Multiple Sewershed Package 5
Solicitation Number: CO-00179
Job No.: 17-4551

ADDENDUM 3
SEPTEMBER 10, 2018

NO.	DATE	REVISION	APP.
MULTI SEWER SHED PK5 SAWS SEWER WORK			
PROJECT LOCATION 2 LAYOUT BYPASS & CONTROL PLAN			
DEVELOPER:		CONT.	
SUBMITTED			
APPROVED			
MAP No.	164566	BUDGET PROJ.	33
95% SUBMITTAL	PROJECT NO. 17-4551	DATE:	9/6/2018
DRAWN: RP	DESIGN: MP	CHECK: KWC	SHEET NO. 7 OF 31

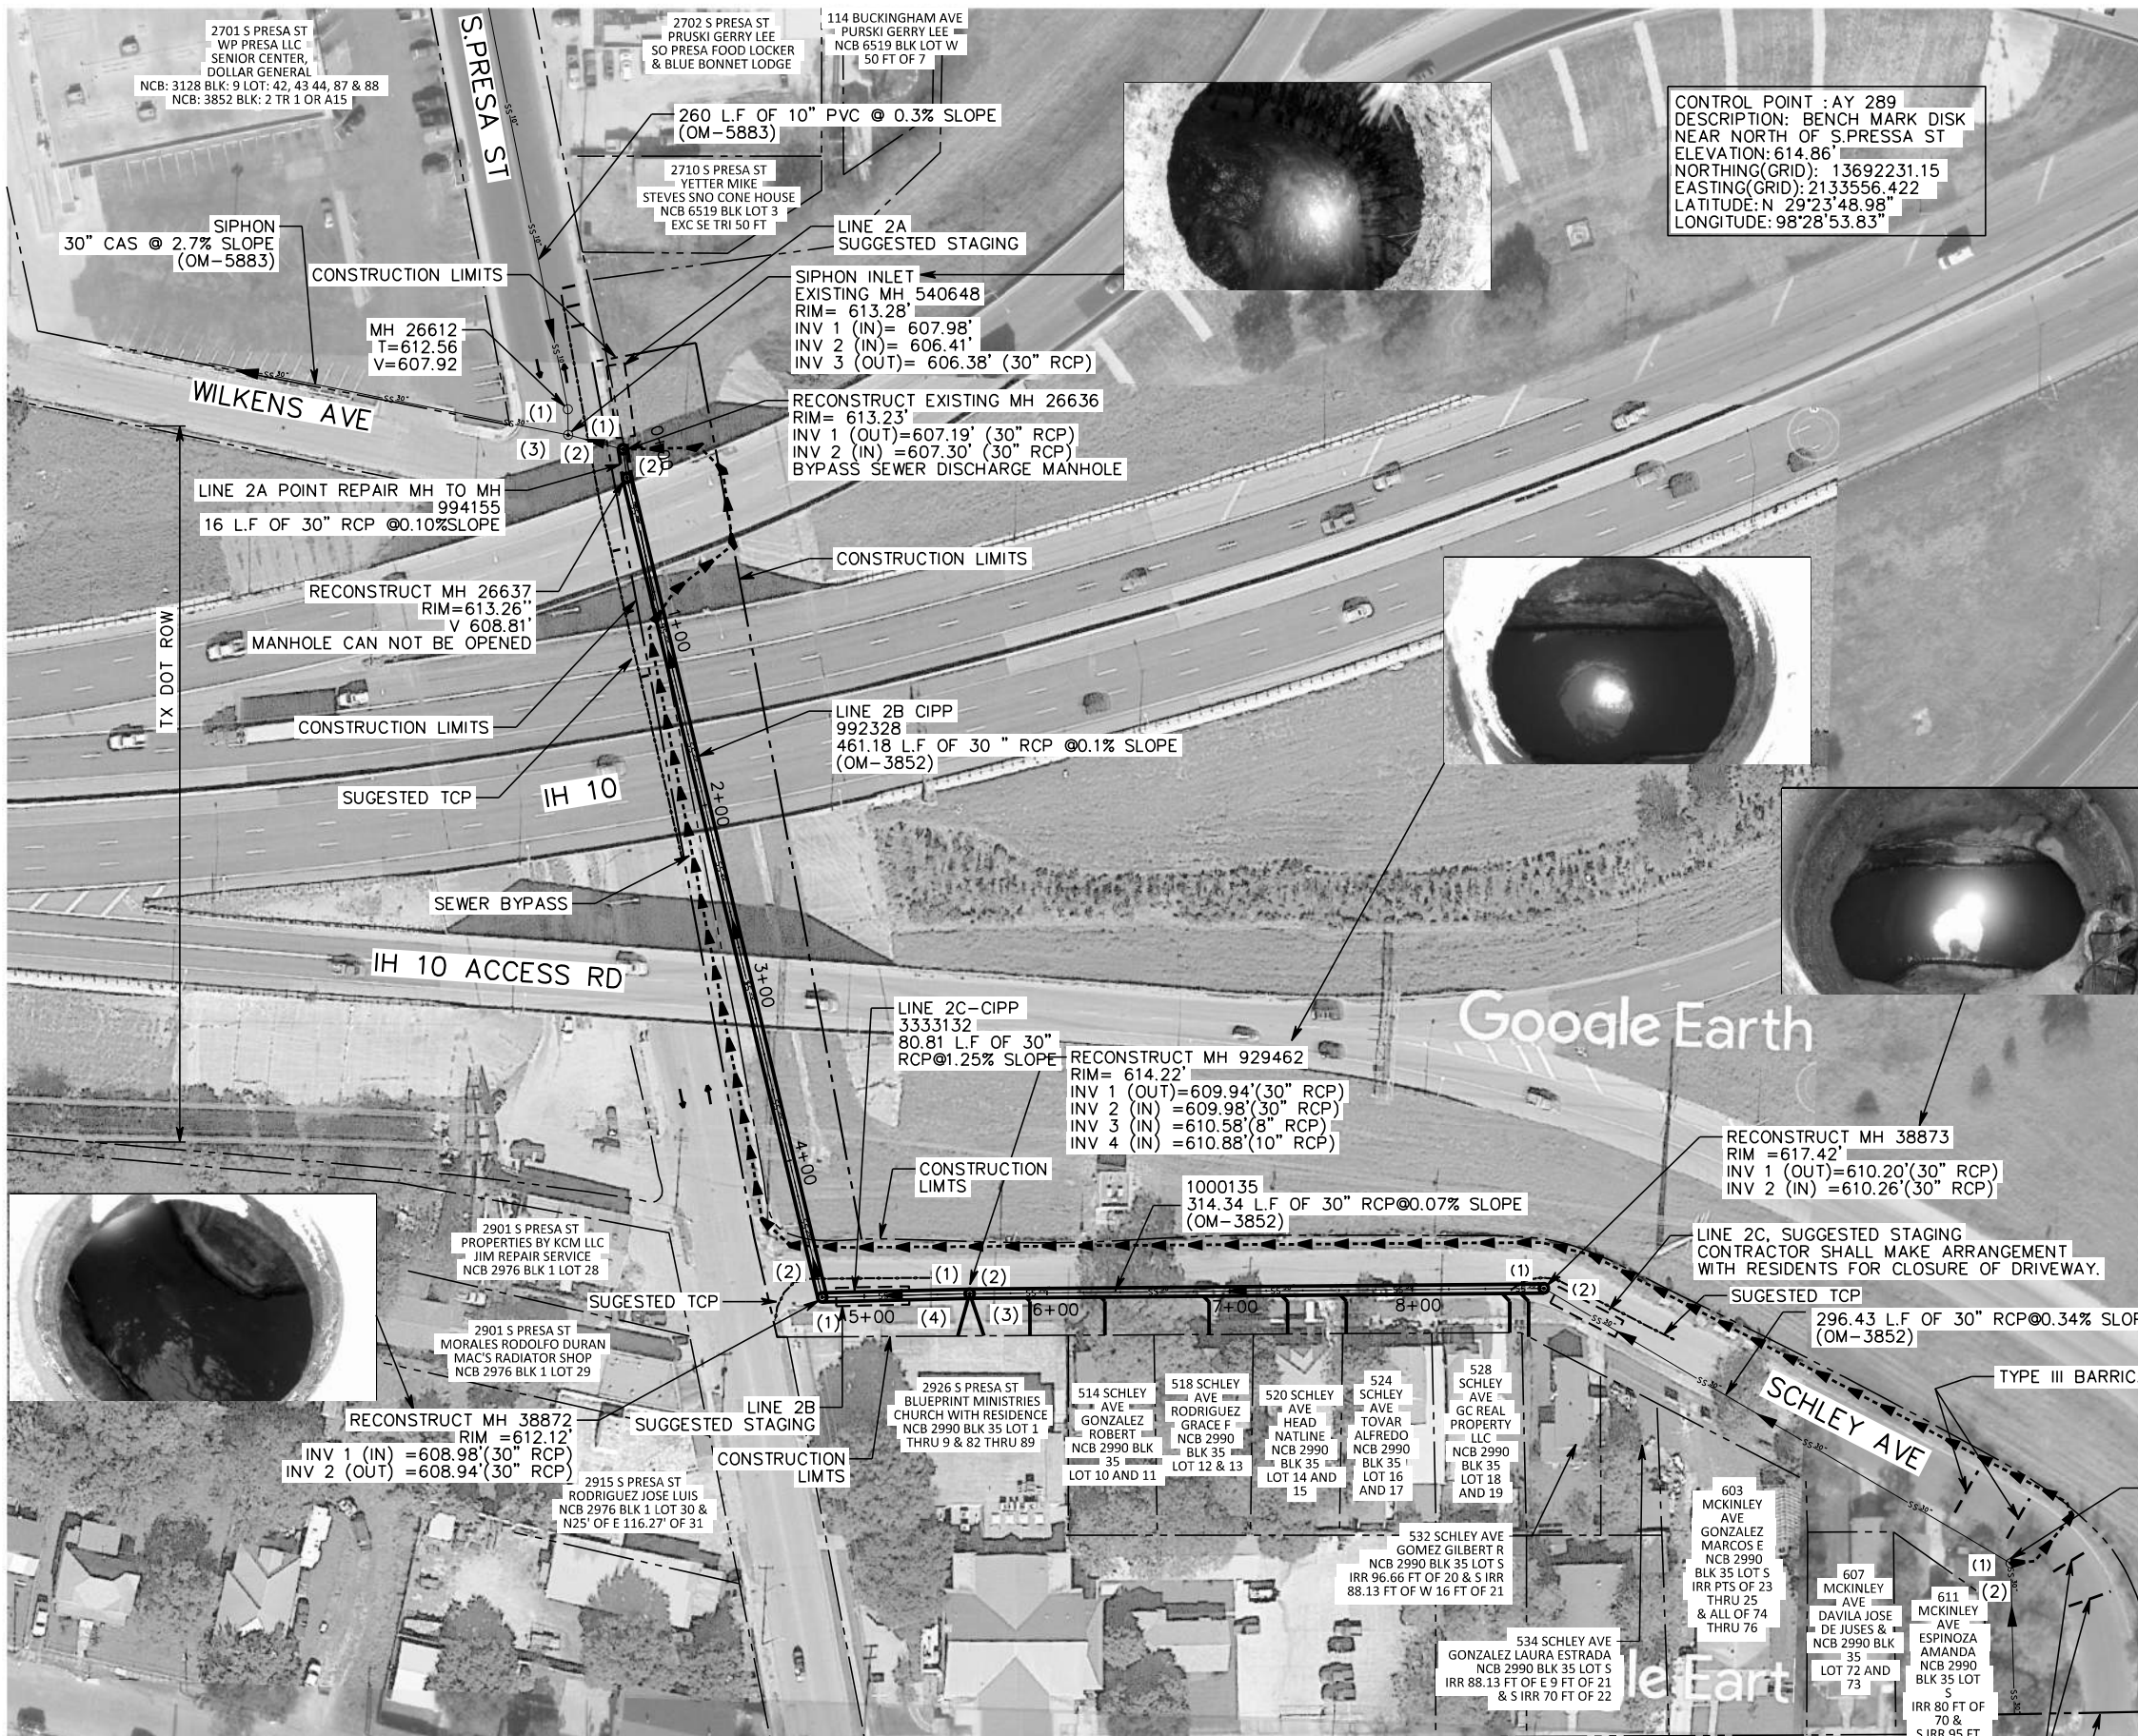
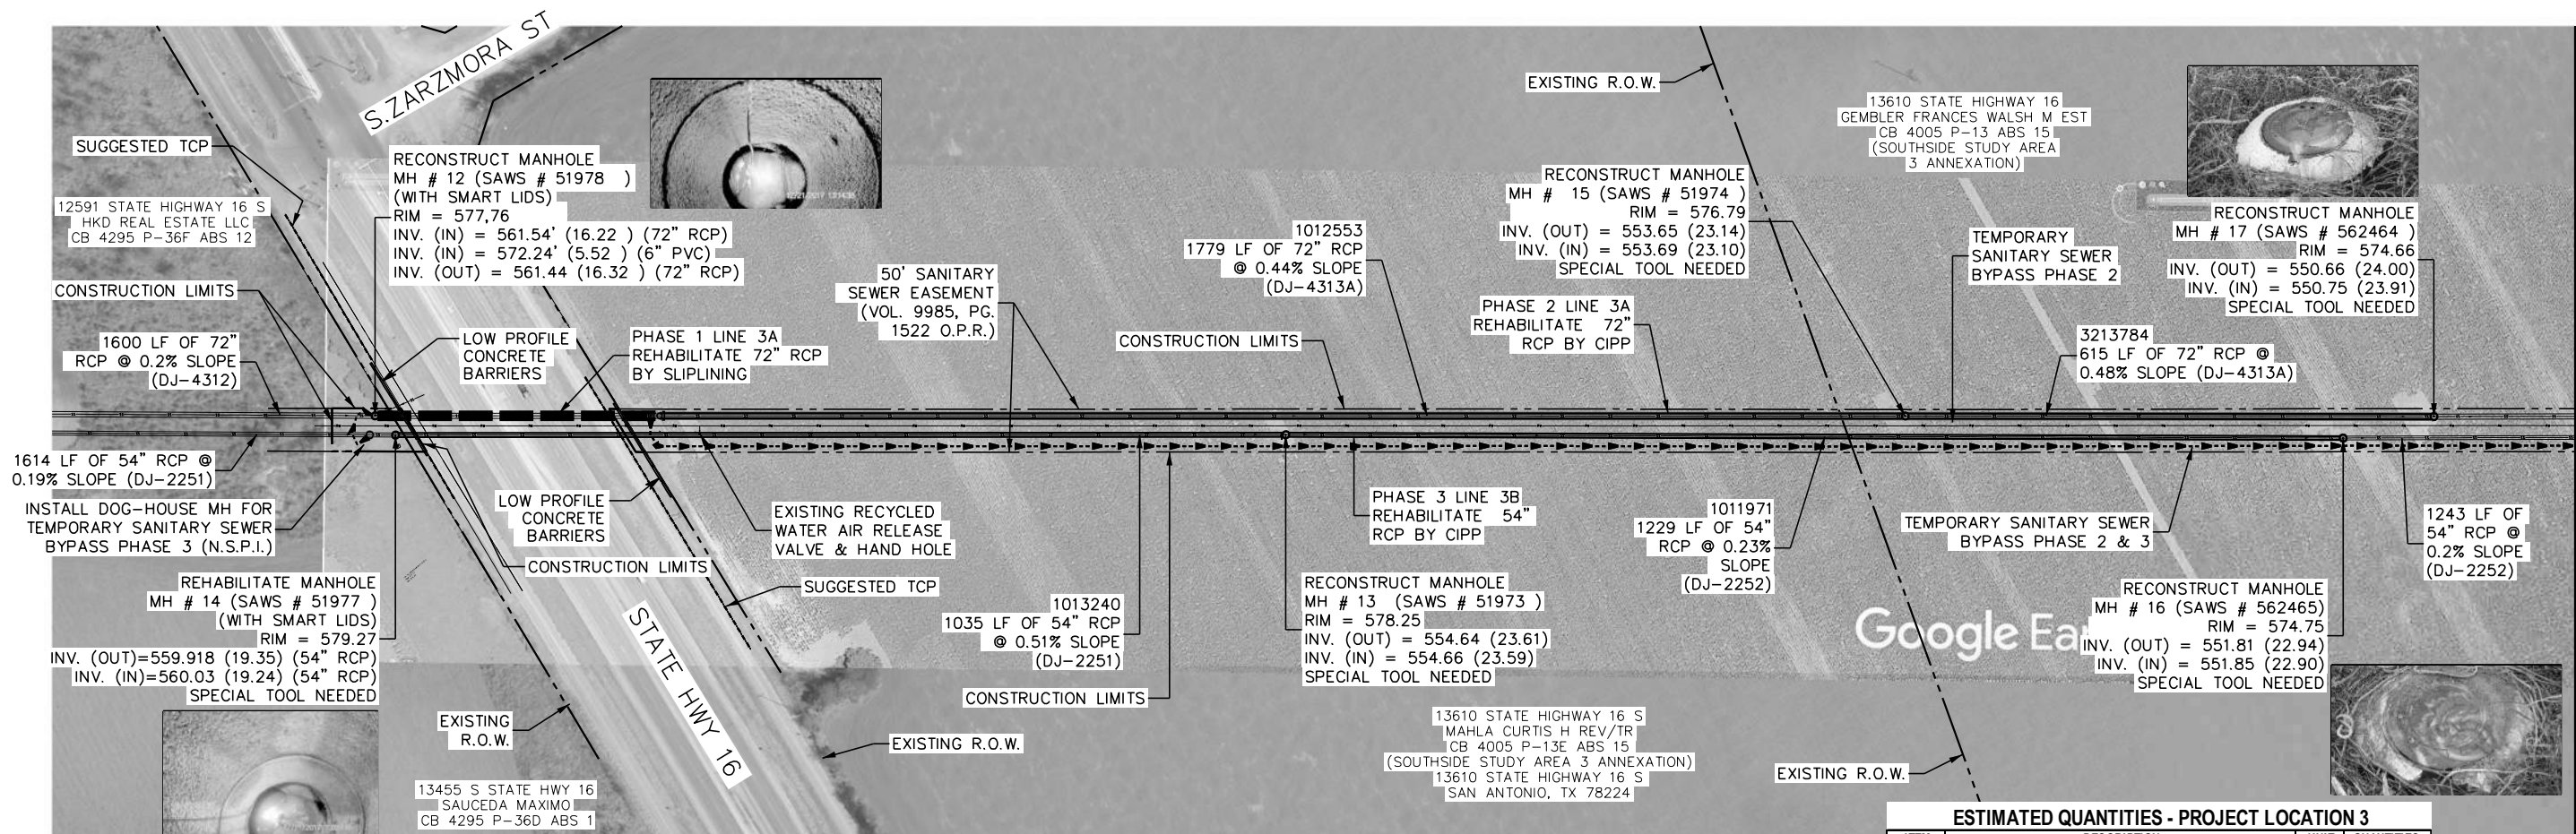
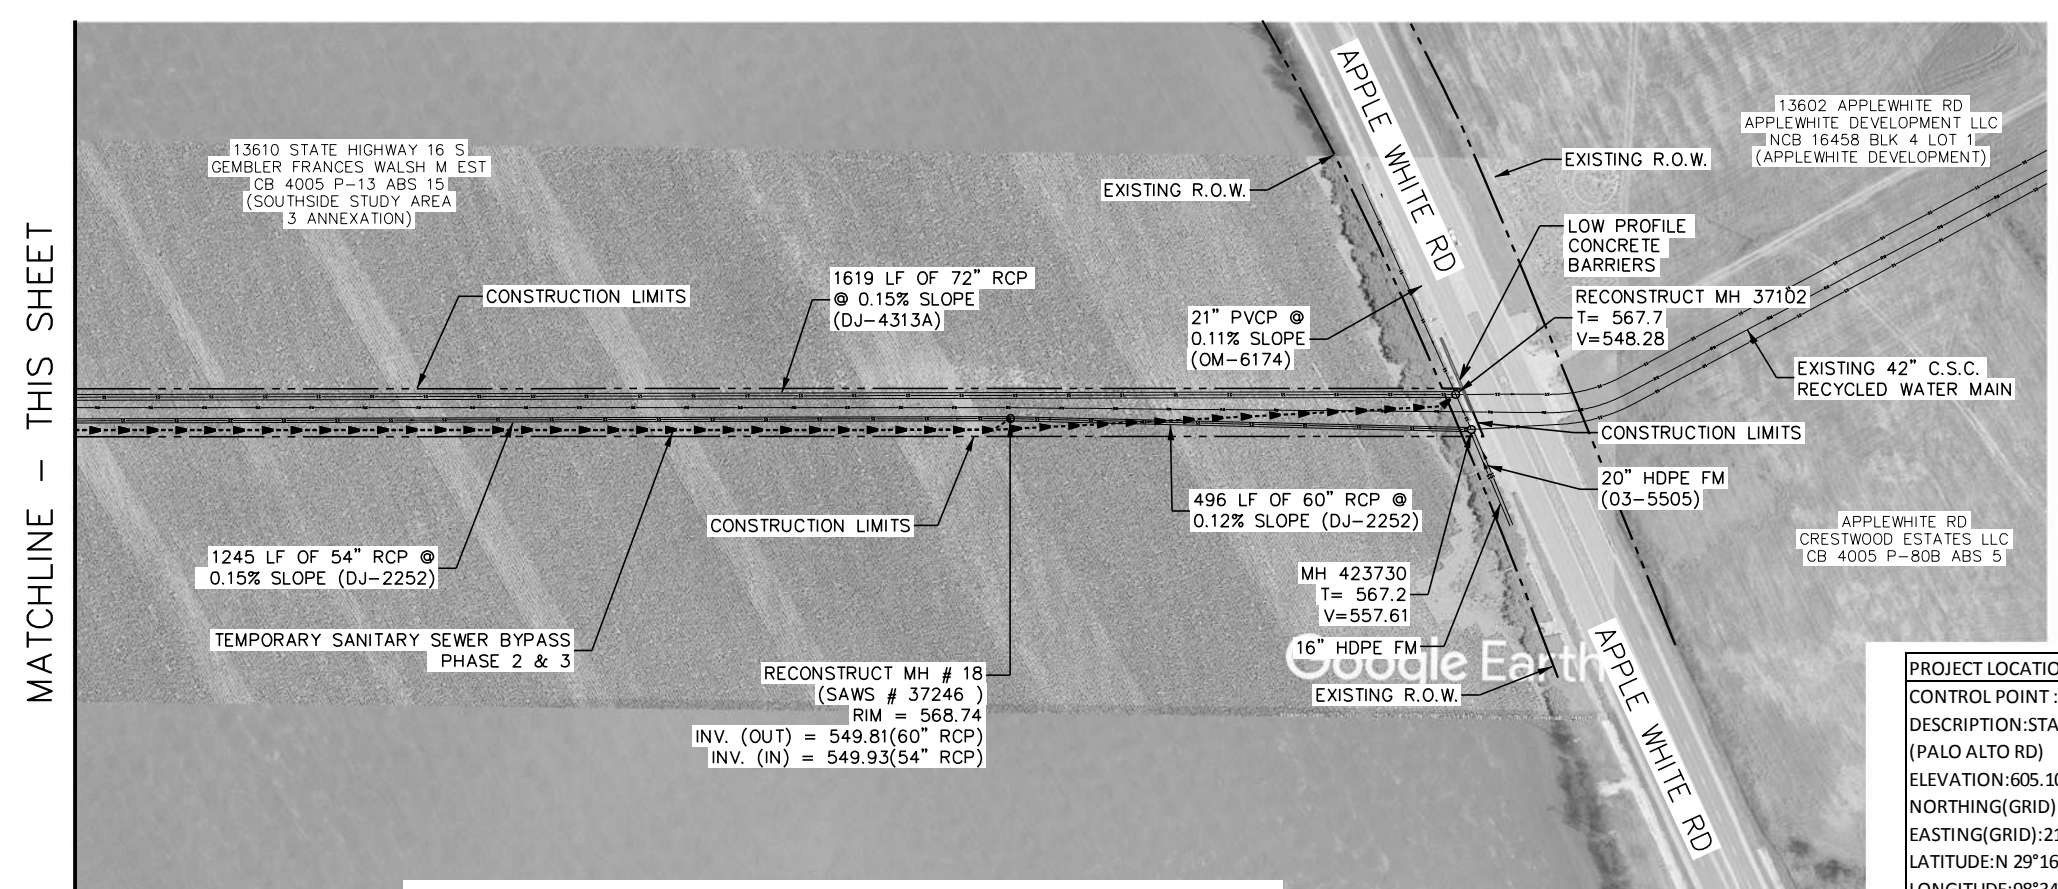
17. **Question:** At Project Location 2 on drawing sheets 7 & 8, the manholes 27999 & 26636 shown to be used for the bypass suction and discharge manholes are also required to be reconstructed, which we understand includes coating the entire manhole interior, including benches and channels, and leakage testing the structure. Since this work would require the manhole being reconstructed to be dry, how can manholes that are being reconstructed also be used as the bypass suction &/or discharge manholes? Please either remove the requirement for these manholes to be reconstructed, redefine the reconstruction for these structures to not include coating & leakage testing, or redefine the limits of the

18. **Question:** At Project Location 2, manhole 26637 on drawing sheets 7 & 8 includes the note “manhole cannot be opened”. Please clarify what this note means.

Response: *All suction and discharge manholes for sewer bypass systems shall be reconstructed and coated as specified, but do not have to be pressure/vacuum tested. Protective coating shall be applied during low flow period and does not have to extend below the low flow line.*

Response: *The surveyor could not open the ring and cover of this manhole for inspection.*

MULTI SEWER SHED PK5
 SAWS SEWER WORK
 PROJECT LOCATION 3 - LAYOUT
 BYPASS AND CONTROL PLAN

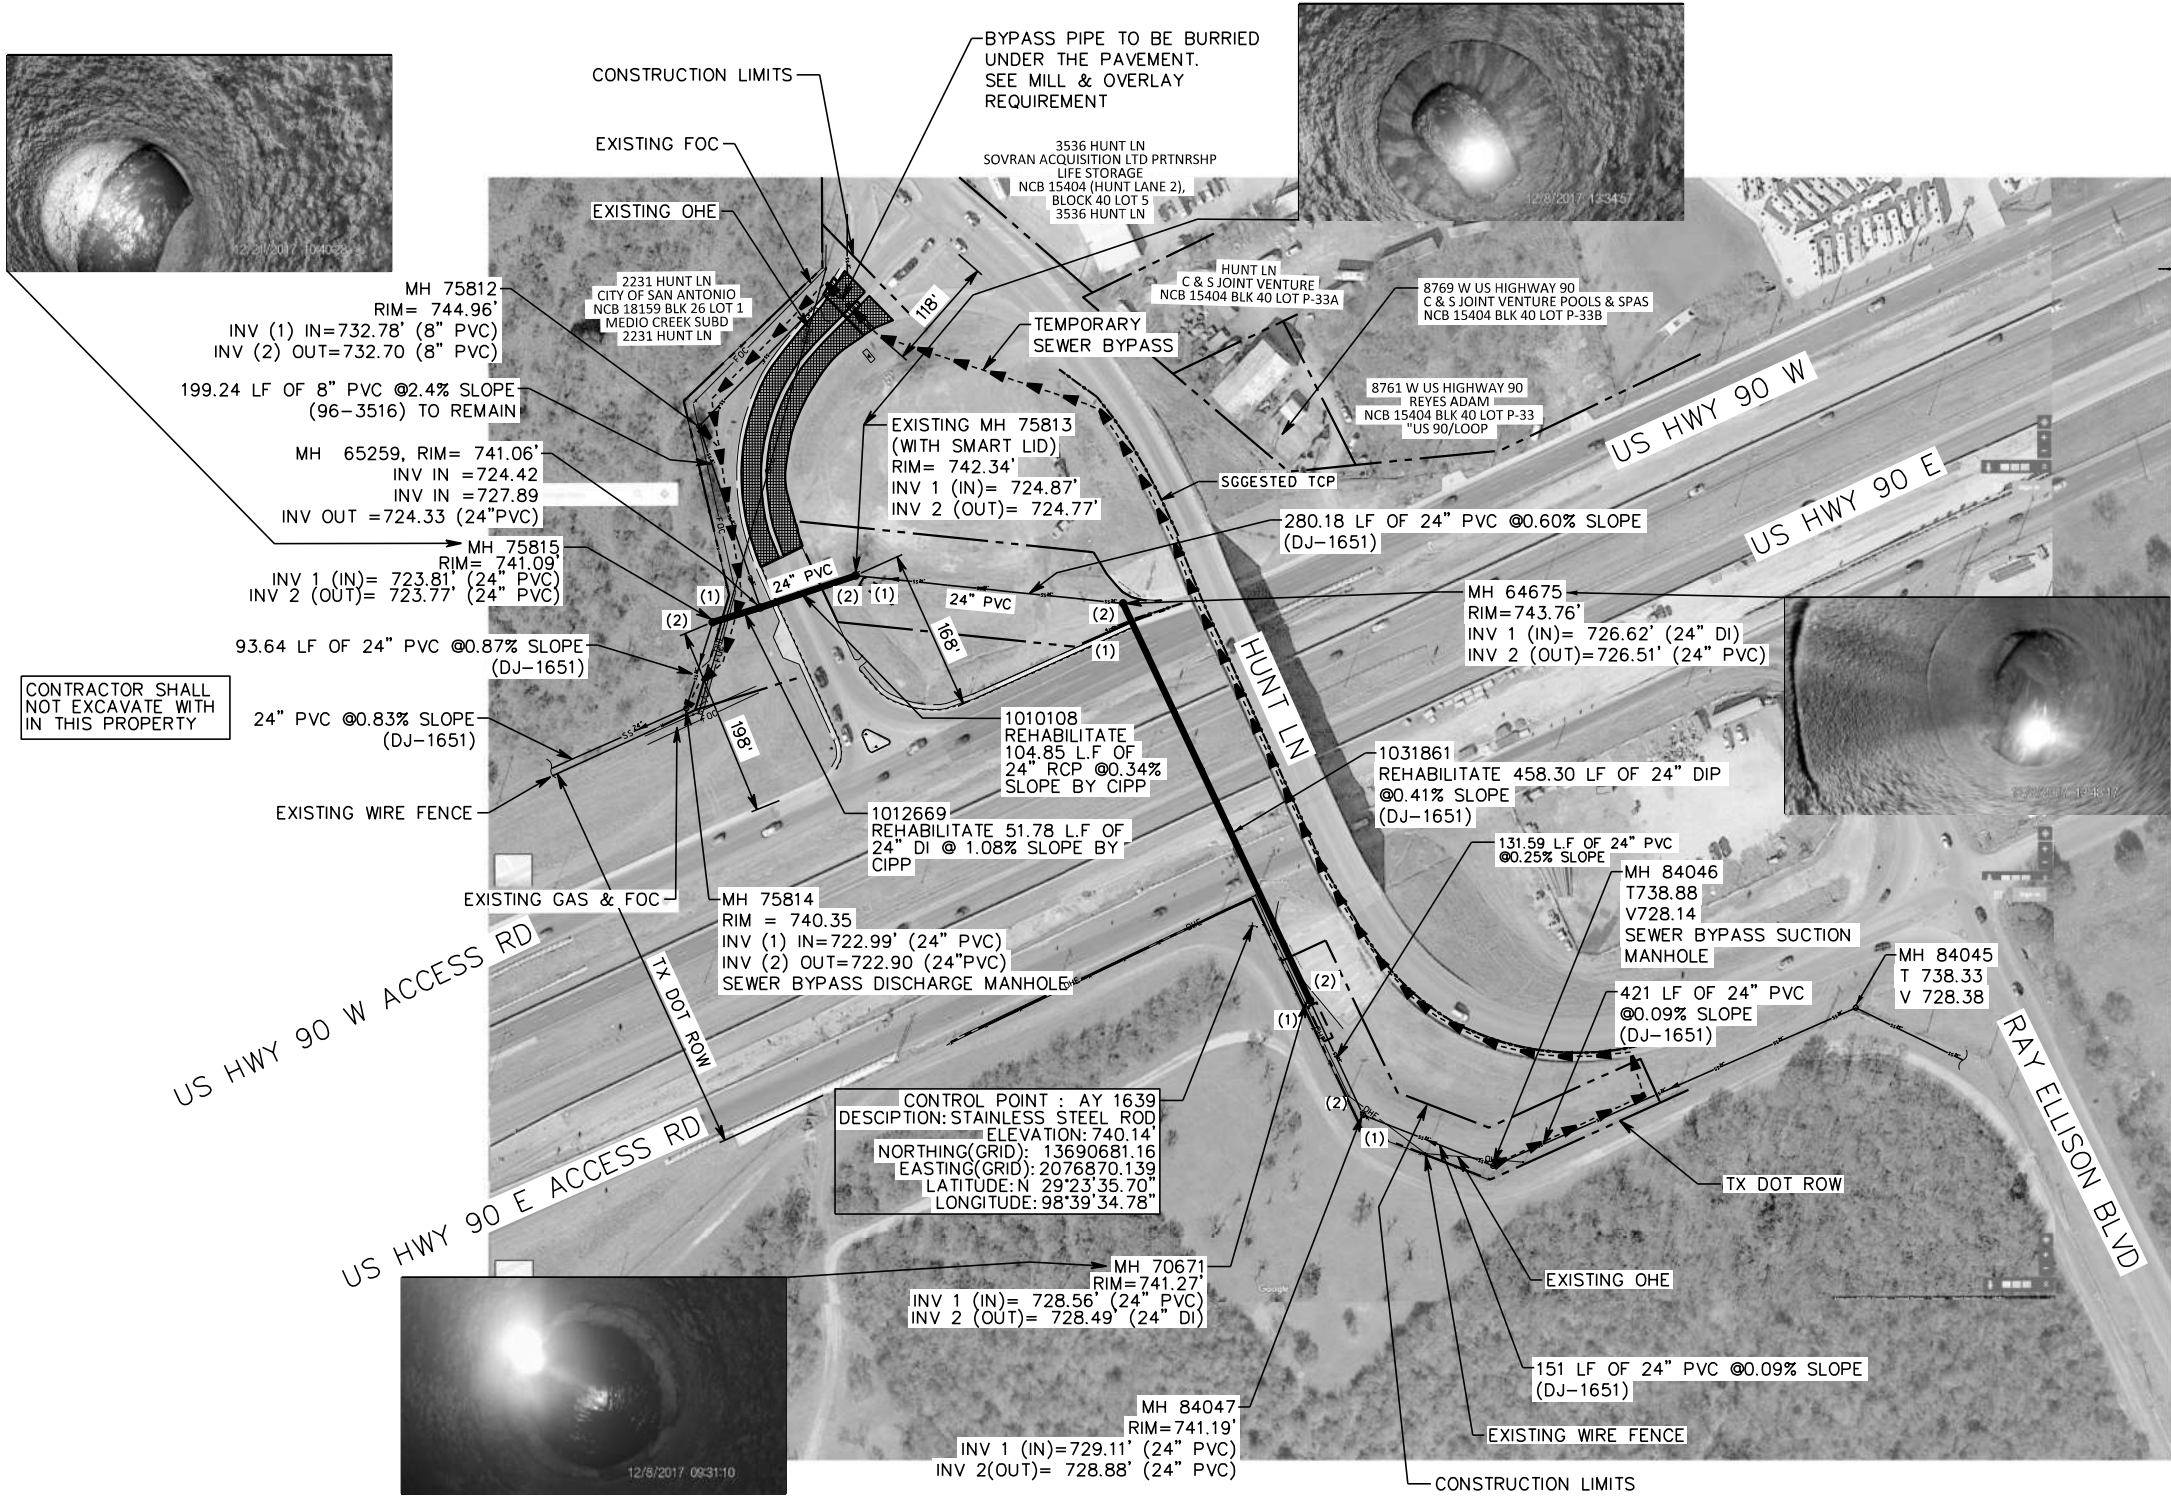
- Project Location 3: The bypass discharge manhole 37102 on drawing sheets 10 & 14 that is shown to be reconstructed.
- Project Location 3: Manhole 51977 on drawing sheets 10 & 11 at the upstream end of the slip-lining section, which is not being bypassed, but is shown to be reconstructed.
- Project Location 5: Manhole 34321 on drawing sheets 18 & 21 at the upstream end of the slip-lining section Line 5C, which is not being bypassed, but is shown to be reconstructed.
- Project Location 5: Manhole 33840 on drawing sheets 18 & 19 at the downstream end of the slip-lining section Line 5A, which is not being bypassed, but is shown to be reconstructed.
